Docket Item # 6 & 7
BAR CASE # 2011-0103, 0104

BAR Meeting
June 1, 2011

ISSUE: Permit to Demolish/Encapsulate & Addition

LOCATION: 519 Wilkes Street

Proposed Door

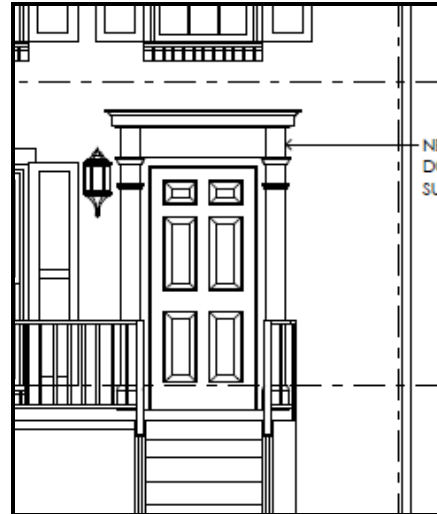
Revival style. Furthermore, Staff has no objection to the proposed height increase and conversion of the attic into a habitable third floor, the extension of the main roof, and the construction of the new dormer, as these alterations are minor in scale and massing. Staff does note that the existing door surround is being altered with a more high-style Colonial Revival surround with Doric pilasters and entablature.

Although, the trim and detailing on the existing entry doors along the blockface are modest; 513 Wilkes has a Colonial Revival portico with large frieze board and molded cornice, and 523 Wilkes has a two--story Colonial Revival porch, Staff feels that the high-style door surround proposed for 519 Wilkes would be compatible with the adjacent townhouses. Staff recommends that the Board support the installation of the proposed entry surround.

Figure 4: Existing and Proposed Front Elevations

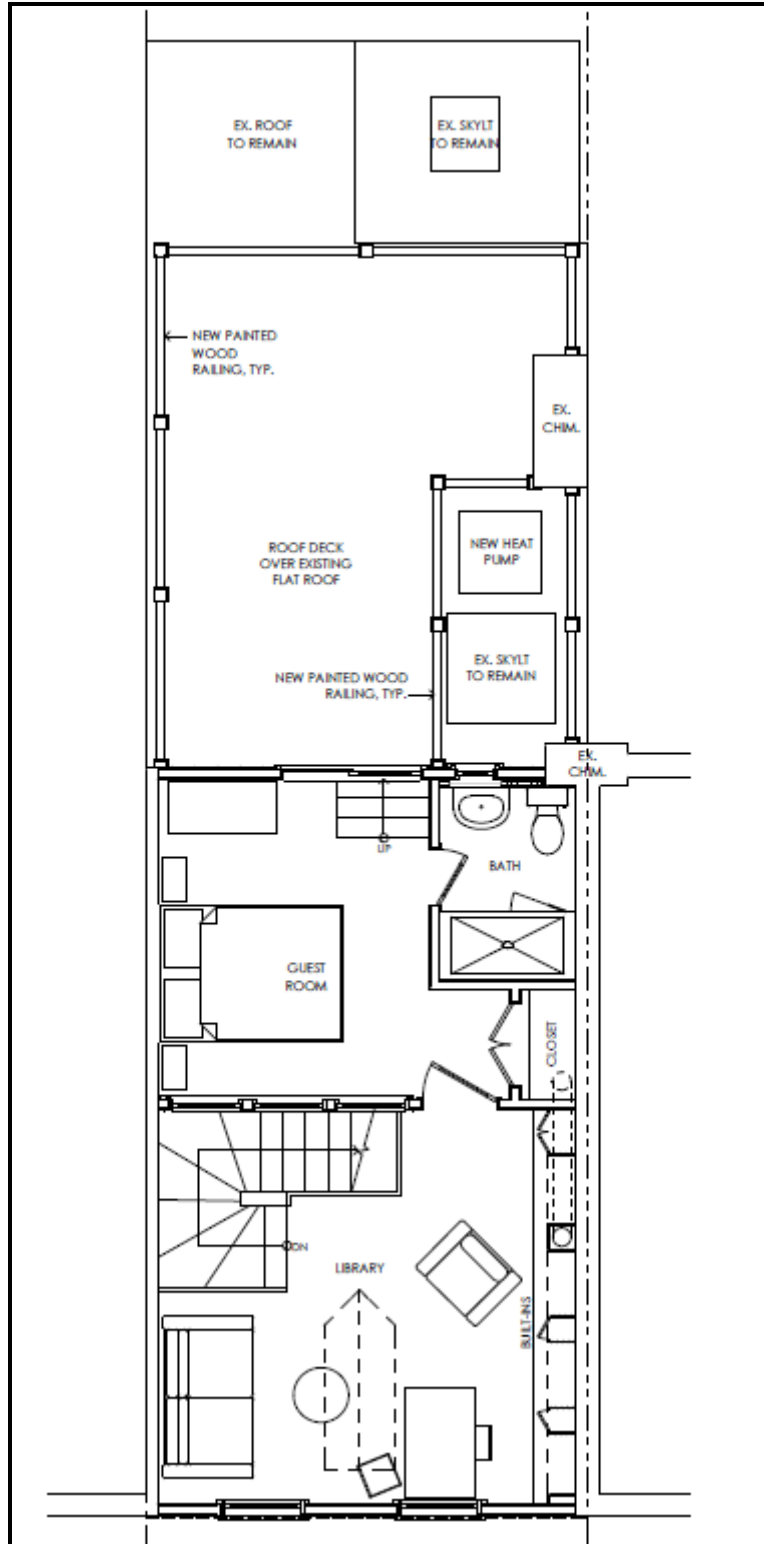
The applicant proposes to construct a new gable roof form on the main body of the house with a ridge height approximately 7 feet 6 inches higher than the existing ridge height, matching the roof form of the neighboring building to the east. The new roof on the main building mass will contain a gable roof with a 4/12 pitch, while the rear portion will continue to have a shed roof supporting a new roof deck. The new deck will contain a new heat pump. The roof deck's balustrade will also serve as required screening for the heat pump. The front façade will be increased in height by approximately 4 feet 10 inches, which will be accomplished by matching the existing stucco. The gutters and downspouts will be painted aluminum to match existing. The new fascia board will align with the neighboring building to the east.

On the front elevation of the addition there will be a centered, pedimented dormer with a multi-light casement window and above the existing second floor windows, two double-hung windows flanked with paneled, operable wood shutters. The existing 9/9 and 6/9 windows on the front elevation which currently contain sandwich muntins will be replaced with double-hung simulated-divided light painted wood windows. A multi-light casement and painted wood, multi-light slider door will be installed on the rear elevation. The simulated-divided-light painted, wood windows will be manufactured by Jeld-Wen with double-insulated glass and 7/8 inch muntins to match existing. The trim will be wood or a painted, solid-wood composite, such as Azek.

A new, painted wood, Colonial Revival style door surround will be installed around the front entry and simple, painted wood lintels will be added above the existing windows.

1. That the color of the new composition roof will conform to the Board's adopted *Roof Policy*.
2. That the new window and door specifications will conform to the Board's adopted *Window Policy*.
3. That the existing windows on the front elevation of the building will be replaced with 6/9 and 9/9 windows that conform to the Board's adopted *Window Policy*.
